APPLICATION FOR PERMIT FOR
HEATING, COOKING OR POWER EQUIPMENT

A building permit is herewith being issued for 272-274 Congress Street to form 3 rooms from one large room as per plan, subject to the following building code requirements.

Subj: Building Permit - 272-274 Congress Street (interior alterations per plan)

Description of Proposed Work
To make changes in structural steel as indicated on plan received on March 29th, 1938 with sundry notations on it made from time to time

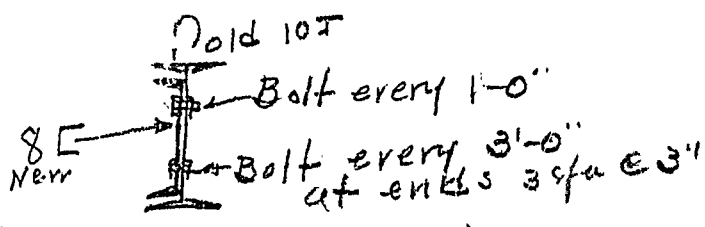
$$R1 = \frac{7.4 + 2.6}{17.5} \times 7500 = 4285.6$$

$$\frac{2.6}{17.5} \times 3000 = 445.6 \quad R = 4731.2$$

$$\text{Max BM} = 4731 \times 7.5 = 35,482 \text{ ft/lbs} \\ \text{against } 40,280 \text{ allowed}$$

10-25 I 22'-0" span good for 11,840 at 16,000
